Proposed Environmental Offset Options for
Clearing Permit Application CPS 8357/1

8.11 PROPOSED ENVIRONMENTAL OFFSET OPTIONS – CLEARING PERMIT APPLICATION FOR PORTION OF AGLIME ROUTE 2 THROUGH THE SHIRE OF VICTORIA PLAINS

Clearing Permit Application 8357/1 – DWER Request for Offset

2 FIGURE 2A MOGUMBER WEST ROAD 1.90 – 2.50 SLK

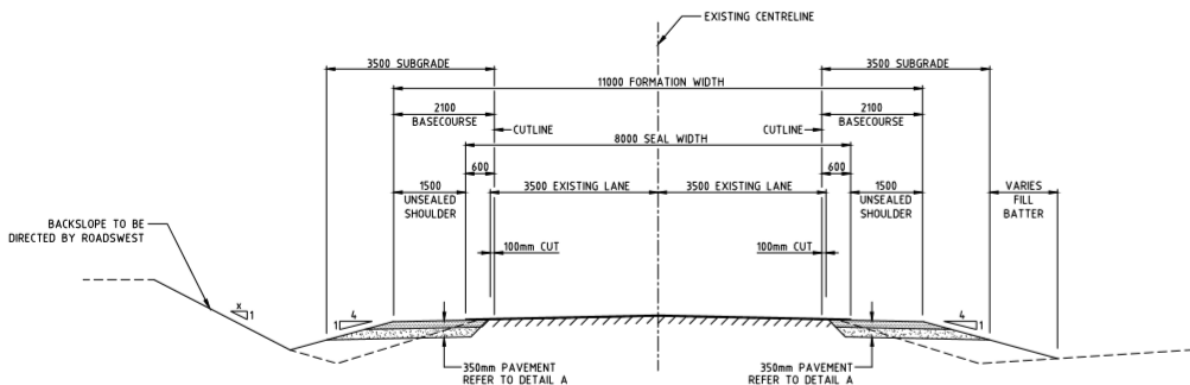
Note trucks running off road on inside of curve – narrow shoulder, encroachment of vegetation on right hand side

Note trucks running off road on inside of curve – narrow shoulder encroachment of vegetation on right hand side

The issue with this location is that the road is not wide enough. Each lane is only 3.5m wide and there is no sealed shoulder. As such large roadtrains on the inside of the curve, experience particularly with their rear trailer, tracking over and running on the unsealed shoulder. This causes further safety and wear issues. The seal edge frets and starts becoming narrower.

The proposed safety treatment is to widen the road formation from 9m to 11m and widen the sealed portion from 7m to 8 to 9m similar to the detail below. This is in keeping with relevant Main Roads standards.

3 FIGURE 2B MOGUMBER WEST ROAD 0.94 – 1.25 SLK

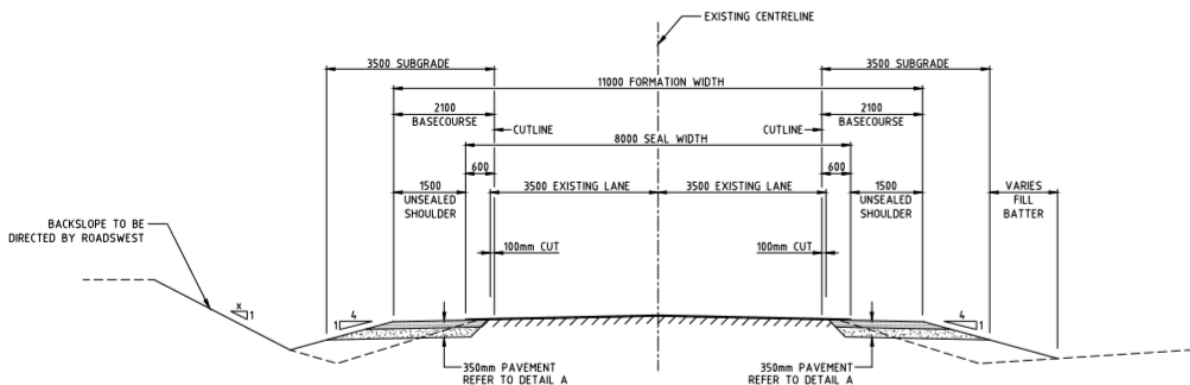
Looking west through right hand curve – note lack of sight distance - unsafe

Note trucks running off road on outside of curve – narrow shoulder encroachment of vegetation.
Note loss of seal edge. Vehicles can loose control on soft shoulders

The issue with this location is that the road is not wide enough. Each lane is only 3.5m wide and there is no sealed shoulder. As such large roadtrains on the inside of the curve, experience particularly with their rear trailer, tracking over and running on the unsealed shoulder. This causes further safety and wear issues. The seal edge frets and starts becoming narrower.

The proposed safety treatment is to widen the road formation from 9m to 11m and widen the sealed portion from 7m to 8 to 9m similar to the detail below. This is in keeping with relevant Main Roads standards.

5 FIGURE 2D CALINGIRI NEW NORCIA ROAD LEFT HAND SIDE 25.12 – 25.31 SLK

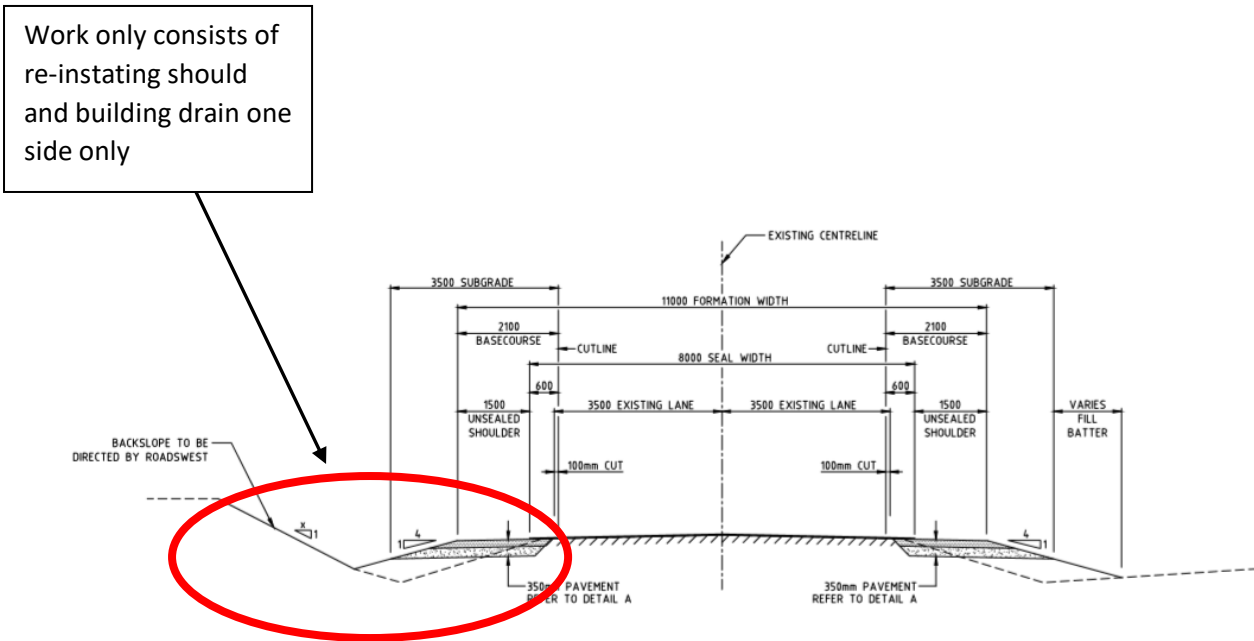
Poor drainage on southern side of road – note water damaging shoulder
and lack of drain for water to flow down

Poor drainage on southern side of road – note water damaging shoulder and lack of drain for water to flow down

- There is a lack of defined drain for the rainfall run off to flow down
- The water is flowing on to the road which may cause vehicles to aquaplane
- The run off is damaging the shoulder and causing scours which will eventually eat into the sealed portion of road.
- The gravel should will become saturated and if a vehicle runs off the road its wheels may sink (rut) and become unstable.

7 FIGURE 2F CALINGIRI NEW NORCIA ROAD LEFT HAND SIDE 17.52 – 17.84 SLK

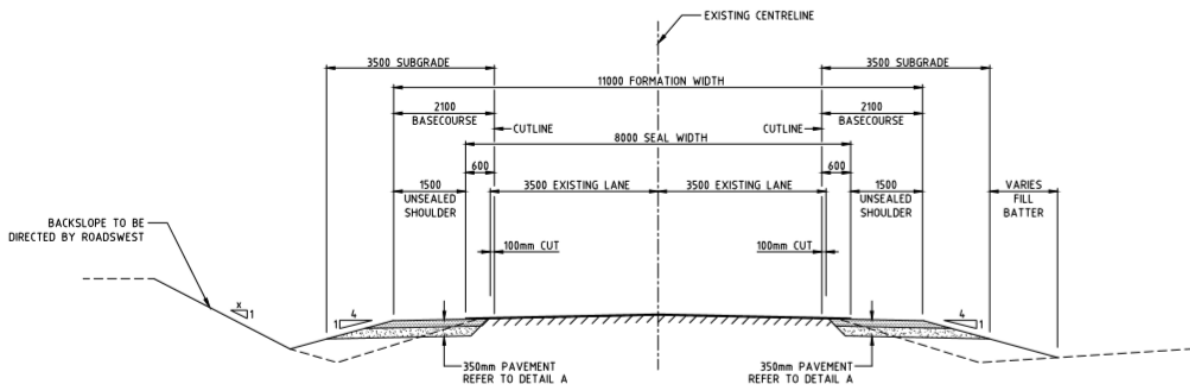
Looking east note narrow shoulder around curve

Looking west note narrow shoulder around curve

The issue with this location is that the road is not wide enough. Each lane is only 3.5m wide and there is no sealed shoulder. As such large roadtrains on the inside of the curve, experience particularly with their rear trailer, tracking over and running on the unsealed shoulder. This causes further safety and wear issues. The seal edge frets and starts becoming narrower.

The proposed safety treatment is to widen the road formation from 9m to 11m and widen the sealed portion from 7m to 11m similar to the detail below. This is in keeping with relevant Main Roads standards.

8 FIGURE 2G CALINGIRI NEW NORCIA ROAD 16.62 – 16.72 SLK

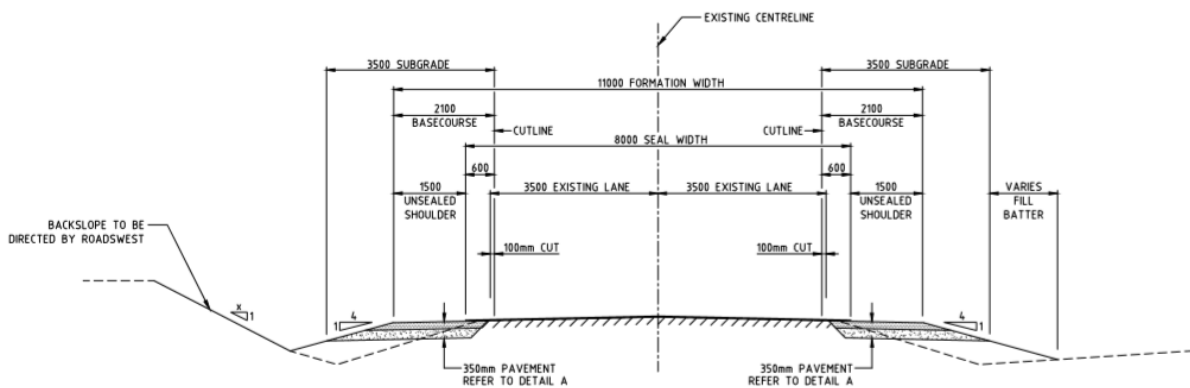
Looking east from southern side of the road - note narrow shoulder and steep batter.
Note batter erosion

Looking east from southern side of the road - note narrow shoulder and steep batter.
Note batter erosion

The issue with this location is that the road is not wide enough. Each lane is only 3.5m – 4m wide and there is very little shoulder with an extremely steep batter. The batters are so steep that due to rainfall run off they are eroding. The edges of the shoulders are soft and cannot support trucks adequately.

The proposed safety treatment is to widen the road formation from 9m to 11m similar to the detail below. This is in keeping with relevant Main Roads standards.
